Notice of Panel Meeting

Council Assessment Panel

6.1 134-140 & 142 Marion Road, WEST RICHMOND

Application No 211/1286/2019

Figure 2: 12.5m HRV exit

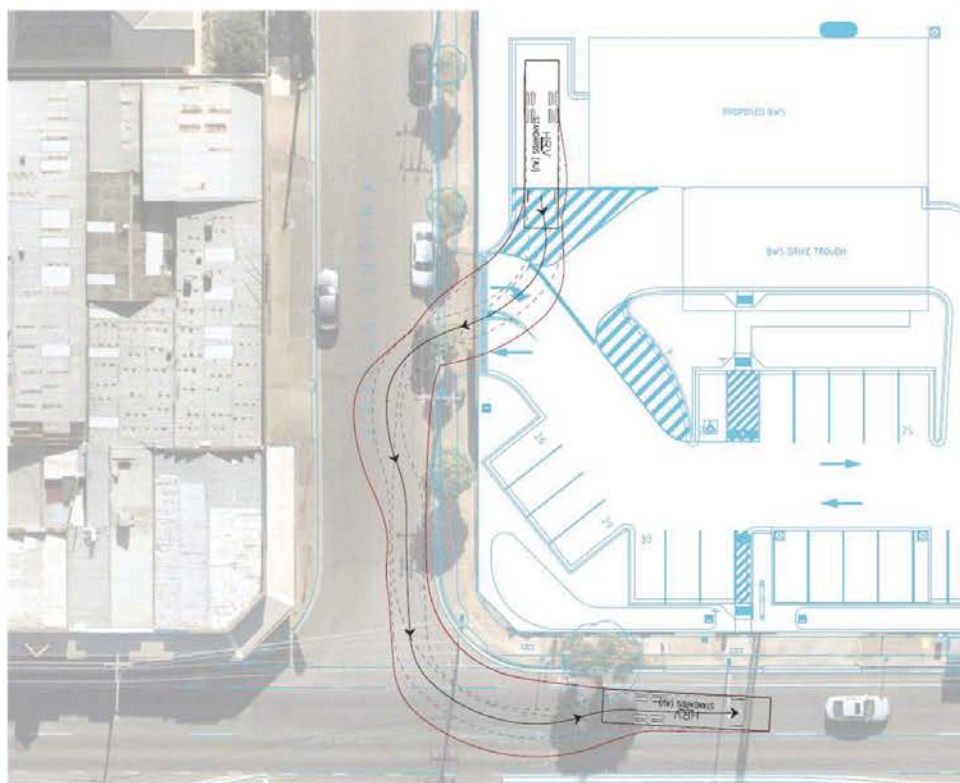
2. The turn path diagram for the HRV truck access to the liquor store loading area (see Figure 6.3 of the GTA report) requires parking to be prohibited along the southern side of Knight Street. The subject parking area is a long-standing arrangement and was provided to assist the existing businesses, therefore its removal is not supported by City Assets. The turn path assessment should be reviewed with the on-street parking on the southern side of Knight Street being retained. The proposed No Stopping controls for the northern side of Knight Street (abutting the subject site) is supported.

Trucks could use the loading zone space when it is not occupied to traverse the street, however if it is occupied there is sufficient space to traverse around a vehicle in this space. The low volume of traffic on Knight Street would typically enable a truck to manoeuvre as shown without conflicting with opposing traffic.

Figure 5: McDonalds 14m Semi site exit turn path

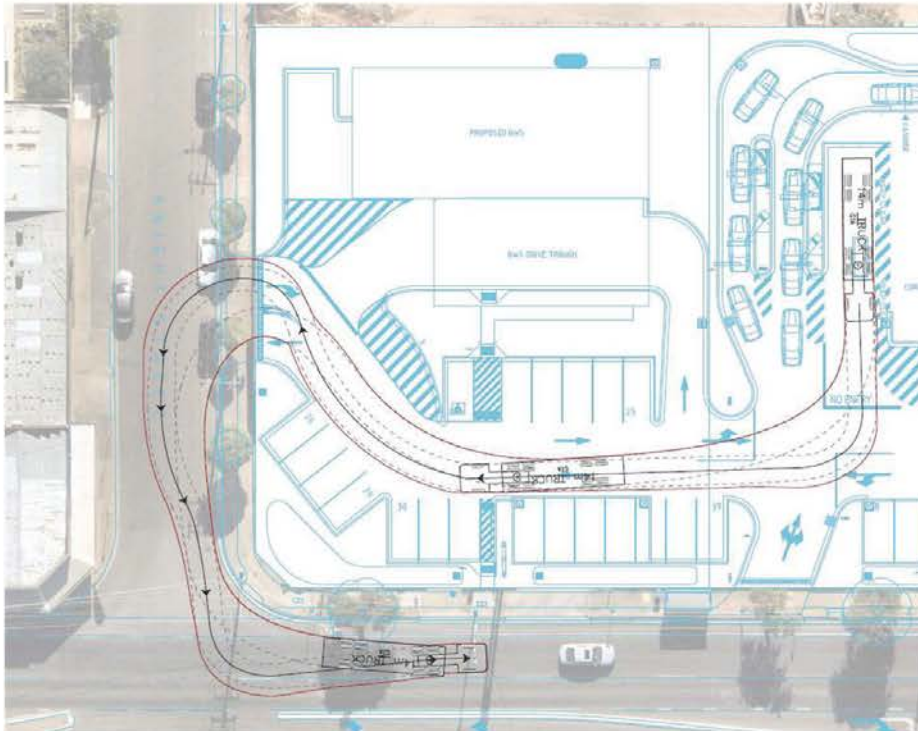
6. *The proposed service vehicle for the fast food outlet involves a large articulated vehicle. Given the size of this vehicle and the acute angle of the exit to Trennery Street, there are concerns with the impact of this vehicle on Trennery Street. Details of this design vehicle (for input into Autotrack) should be provided to allow Council to check and verify the exit turn path into Trennery Street. Even as shown in Figure 6.2 of the GTA report, where the driver of the articulated vehicle has to make the correct positioning and turn necessary, there is potential for entry movements from Marion Road into Trennery Street to be obstructed already. Poor positioning of the exit vehicle would make the situation worse.*

A review of the McDonalds delivery truck has been undertaken given the comments raised by Council, with a revised exit path proposed via the BWS driveway to Knight Street. This will enable the McDonalds delivery truck to avoid having to turn right onto Trennery Street and avoid the potential concerns raised by Council. A revised delivery truck path is shown in Figure 5 below.
